**COMMENTS OF THE
NATIONAL PETROCHEMICAL & REFINERS ASSOCIATION (NPRA)
ON EPA'S DRAFT ANALYSIS OF CETANE AND NO_x EMISSIONS
FROM HEAVY-DUTY HIGHWAY ENGINES**

RE: EPA Draft Technical Report, *The Effect of Cetane Number Increase Due To Additives on NOx Emissions from Heavy-Duty Highway Engines, June 2002*

Comments on
The United States Environmental Protection Agency
Office of Transportation and Air Quality
Assessment and Standards Division
Draft Technical Report:
*The Effects of Cetane Number Increase Due to Additives on NOx
Emissions from Heavy-Duty Highway Engines*
(June 2002)

Subject: Comments on the EPA's Draft Technical Report – "The Effect of Cetane Number Increase Due to Additives on NOx Emissions from Heavy-Duty Highway Engines"

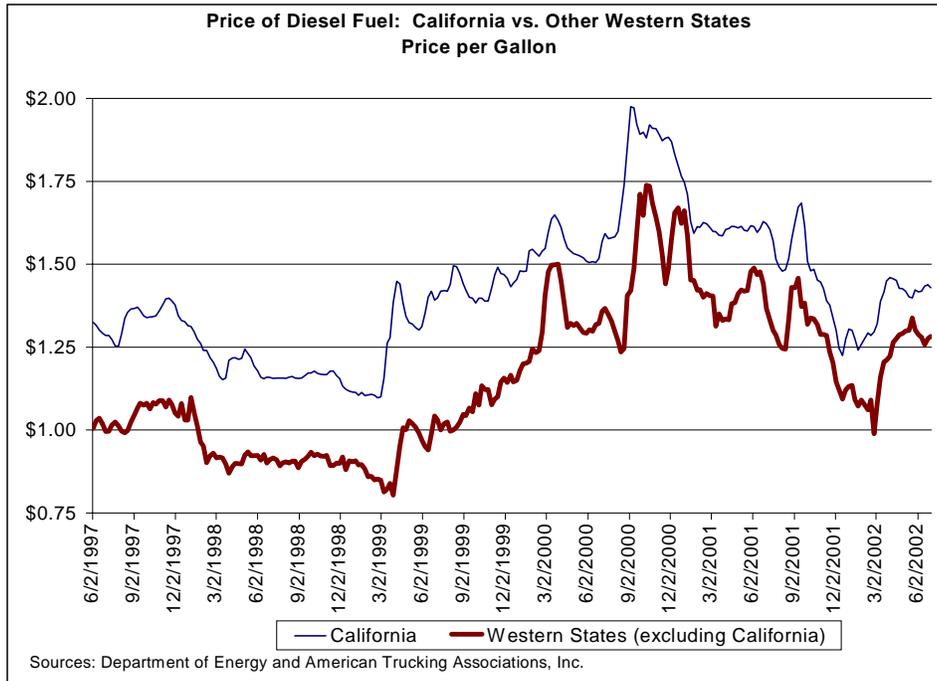
depicted in the above chart, however, indicate the retail cost to the consumer is on average 25.9 cents more per gallon than the retail cost of diesel in states bordering California.¹³

The primary reason for these price differentials is that the boutique fuel mandate has isolated the California diesel fuel market from the rest of the country. This means that California diesel fuel consumers must rely on output produced solely in their state. Other western states have access to diesel refined in other states and other regions. The inability to transfer fuel to California from other states inhibits the efficient functioning of the market, resulting in prolonged shortages and significant price spikes. Indeed, California's boutique fuel requirement has resulted in the inability to respond to fuel shortages by simply importing additional fuel from neighboring jurisdictions, creating price spikes of more than 40 cents per gallon.¹⁴

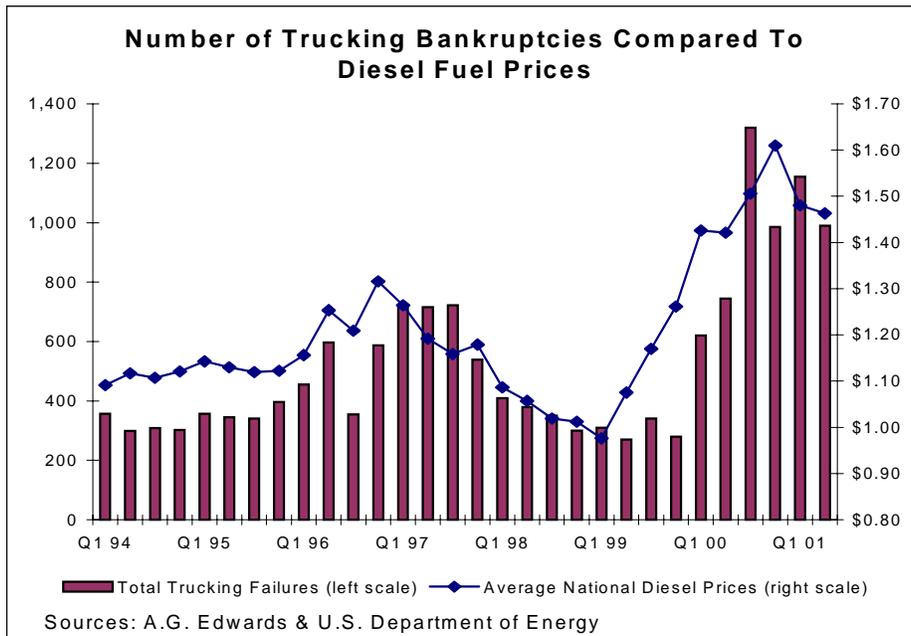
The graph above demonstrates the tight correlation between escalations in the price of diesel fuel and increased bankruptcies in the trucking industry. While the industry can pass through to shippers predictable, long-term diesel price increases, unpredictable price spikes, which are exacerbated by boutique fuels, will force many small operators into bankruptcy.
